ORIGINATION FORM

Proposed Revisions to a Standard Plans Index

Index Number: 455-160
Sheet Number (s): 1
Index Title: 60" Prestressed CFRP & SS Concrete
Cylinder Pile

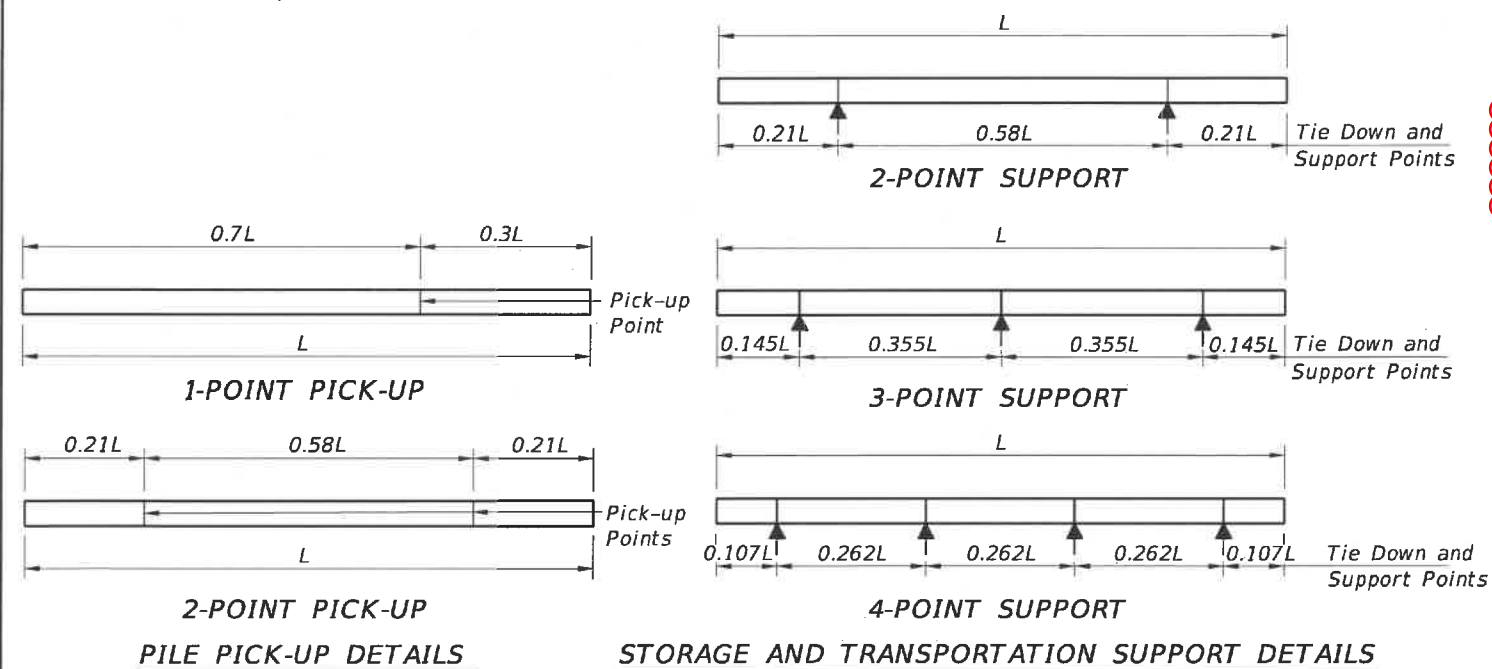
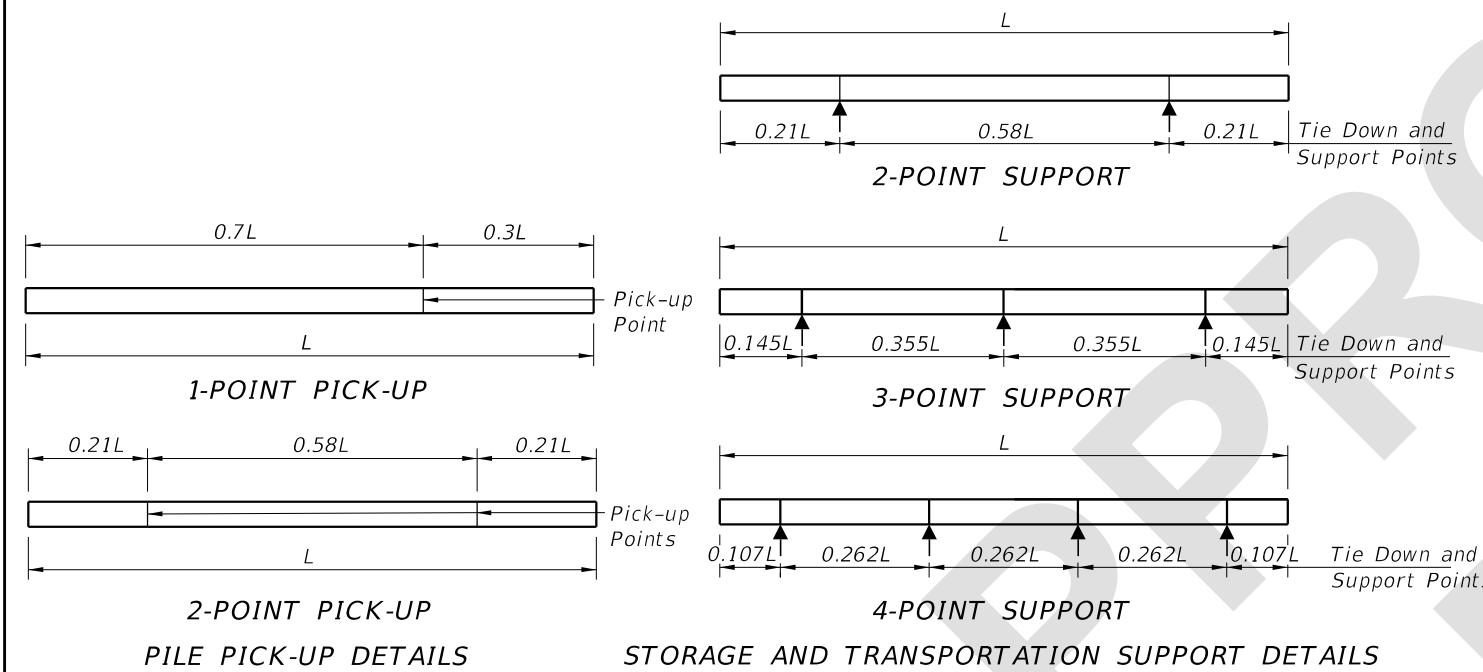
Changed Class V (Special) concrete to Class V.

1. Work this Index with the Pile Data Table in the Structures Plans.
2. Concrete:
 - A. Piles: Class V
 - B. Splice Collar: Class IV
 - C. See "GENERAL NOTES" in the Structures Plans for locations where the use of Highly Reactive Pozzolans is required.
